United States Patent and Trademark Office

APPLICATION NO.	FILING DATE	FIRST NAMED INVENTOR	ATTORNEY DOCKET NO.	CONFIRMATION NO.	
10/820,116	04/08/2004	Lan-Shi Huang	3624-0163PUS1	8640	
2292	7590 11/22/2005		EXAMINER		
BIRCH STE PO BOX 747	WART KOLASCH &	SCHRODE, WILL	SCHRODE, WILLIAM THOMAS		
FALLS CHU	RCH, VA 22040-0747	ART UNIT	PAPER NUMBER		
			3676

· · · · · · · · · · · · · · · · · ·	Application No.	Applicant(s)		
Office Action Summary		10/820,116	HUANG ET AL.		
		Examiner	Art Unit		
		William Schrode	3676		
The MAILING DATE of this communication appears on the cover sheet with the correspondence address Period for Reply					
A SHORTENED STATU WHICHEVER IS LONGE - Extensions of time may be availa after SIX (6) MONTHS from the i - If NO period for reply is specified - Failure to reply within the set or 6	R, FROM THE MAILING DA ible under the provisions of 37 CFR 1.13 nailing date of this communication. above, the maximum statutory period we extended period for reply will, by statute, later than three months after the mailing	'IS SET TO EXPIRE 3 MONTH() ATE OF THIS COMMUNICATION 16(a). In no event, however, may a reply be tim rill apply and will expire SIX (6) MONTHS from cause

Examiner's Attachment 1

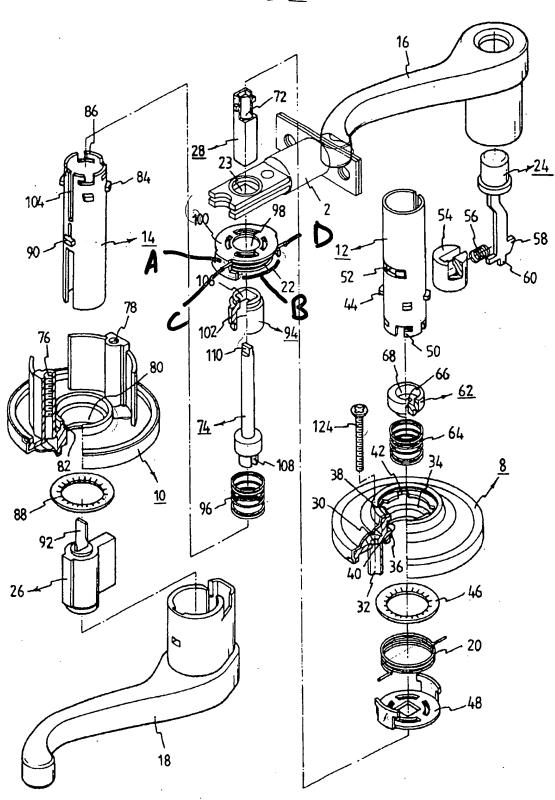
In response to the applicant's argument regarding the 102 rejection for claim 1, the examiner would like to point out that Kim shows a return spring (22) extended through the notch (i.e. the ends C and D extend through notch B), so that the ends of the spring exert a bias force on the positioning plates of the rose positioning plates (i.e. the ends C and D exert a bias force on the plates 76 and 78 as stated by Kim at column 4 lines 25-28) and where the notch has a width extending between the two ends of the annular wall where the width is smaller than the diameter of the return spring so that it cannot be disengaged from the return device. Kim teaches that the outer perimeter of the spring is elastically fitted against the inner perimeter of the annular wall. Since the annular wall is curved around the perimeter of the return device and the two ends of annular wall that form the notch is less than 180 degrees, the notch is smaller than the spring diameter. Thus, Kim's spring cannot be disengaged from the return device. In response to applicant's argument that the references fail to show certain features of

applicant's invention, it is noted that the features upon which applicant relies (i.e., The wall extends through an angle considerably greater than 180 degrees.) are not recited in the rejected claim(s). Although the claims are interpreted in light of the specification, limitations from the specification are not read into the claims. See *In re Van Geuns*, 988 F.2d 1181, 26 USPQ2d 1057 (Fed. Cir. 1993).
